<b>DOCKETED</b>	
<b>Docket Number:</b>	19-BSTD-03
<b>Project Title:</b>	2022 Energy Code Pre-Rulemaking
<b>TN #:</b>	235654
<b>Document Title:</b>	GE Appliances Comments in Response to Staff Workshop Presentation on Range Hoods
<b>Description:</b>	N/A
<b>Filer:</b>	System
<b>Organization:</b>	GE Appliances
<b>Submitter Role:</b>	Public
<b>Submission Date:</b>	11/17/2020 4:37:07 PM
<b>Docketed Date:</b>	11/17/2020

**GE Appliances Comments in Response to Staff Workshop  
Presentation on Range Hoods**

Re: Comments in Response to the November 3, 2020 Staff Workshop Presentation on Range Hood Capture Efficiency

Re: Proposed 2022 California Energy Code (Title 24, Part 6), Multifamily Indoor Air Quality - Kitchen Range Hood Capture Efficiency Requirement

Figure 17(slide 66)

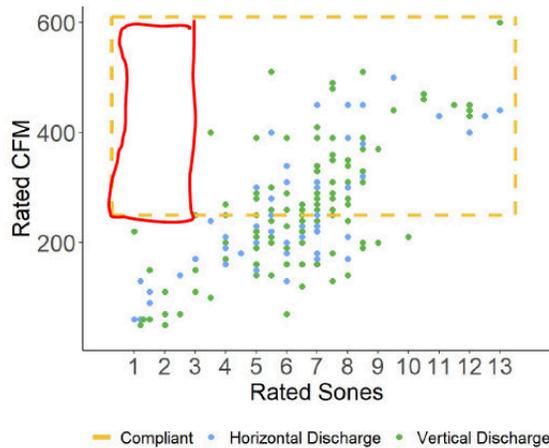
On Figure 17 (slide 66), these measurements are not at the NIF that is proposed. The yellow dotted box outlines products that would be compliant under the proposed requirement of having a minimum airflow of 250 CFM at 0.1 in. w.c. or higher. It is noted (section 3.2.2.3, p. 89), “As shown in the below figures, the proposed minimum requirement of 250 cfm for range hoods would cause several products that currently comply with the 2019 Title 24, Part 6 requirement of at least 100 cfm to no longer comply, but most would.” There are no products on the chart that would meet 250 CFM and 3 sones as shown by the red box below. (Note - As a reminder, the CEC acceptance of working speed for sound measurements was not accepted by ASHRAE SSPC 62.2). Therefore, 250 CFM was not chosen based on a balance of performance and sound for a given speed setting.

Figure 16 (slide 68)

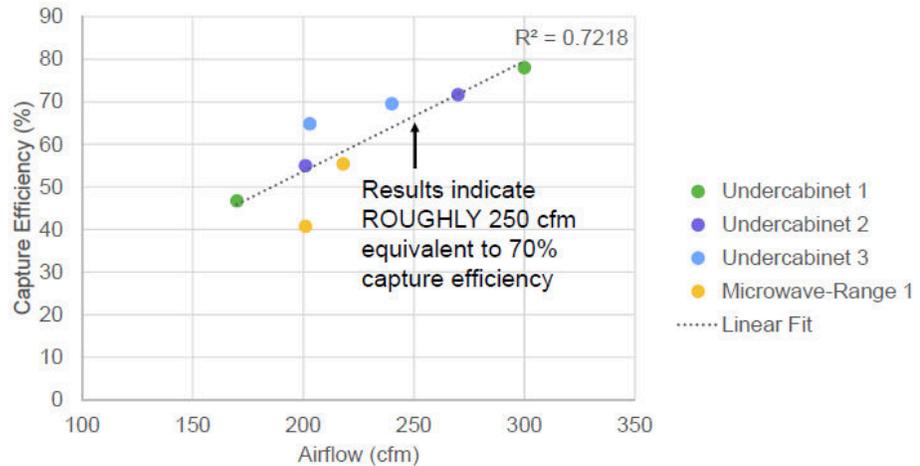
On Figure 16 (slide 68), the ROUGHLY 70 % CE value shown on the line is more like 65 %. It is clear that CASE does not feel confident in the current proposal as the chart says ROUGHLY highlighted by the capital letters. From the graph, the CE is below the 70% horizontal grid line at 250 cfm. This highlights the 250 CFM value was chosen arbitrarily. The data on Figure 16 does show the shift due to different backpressures (note - neither point is at NIF). If NIF is higher than 0.25 in. w.c., the flow may be much

lower depending on the duct. This chart also shows that the slope of the airflow as a function of pressure based on the two data points, varies significantly between individual products. The two products that are on the line (Undercabinet 1 & 2), while having the same slope, have significantly different airflows from 0.1 to 0.25. This data does not support the use of the current HVI rating condition (0.1 in. w.c.) as indicative of field performance.

In discussion on Figure 16 (slide 68), the CASE reports states (section 3.2.2.2, p. 85), “the higher static pressure (0.25 in. w.c.) is a more accurate representation of installed conditions,” yet the CE & CFM data in Figure 16 show no units at this pressure meet the CE/CFM requirements.

- The one OTR that is on the chart is below the best-fit line and below 250 CFM so the tested OTR is not compliant to the proposed limits. OTR’s were also not equally represented in the data (1 of 4 units charted even though 2 OTR’s were tested). Additional testing of OTR’s is needed to show that the level being set does not intentionally eliminate OTR’s for use in multi-housing units. It was also previously noted that the ASTM specification does not have requirements for OTR’s so this may explain some of the issues with these data points.
- Two of the eight points are above 250 CFM or above 70 %. This would show a 40 % compliance rate based on the samples tested (2 of 5). However, the points shown are clearly high speed or boost speed settings and 0.1 in. w.c., which will likely have high noise levels and will likely not be used by consumers without significant education and reluctance.

The chart clearly highlights the value is based on a small sample size. A 0.72  $R^2$  value says that only 72 % of the variation is captured by the analysis of CE vs. CFM. However, the  $R^2$  in the CASE report is 0.6945 (section 3.2.2.2, p. 86). This value needs to be higher to create a non-arbitrary value. The  $R^2$  increased to 0.87 when the OTR was

removed but that is more likely tied to the fact that 3 of the 4 points in the graph were not OTR's and thus one point does not statistically represent all OTR's and may be part of a different population.
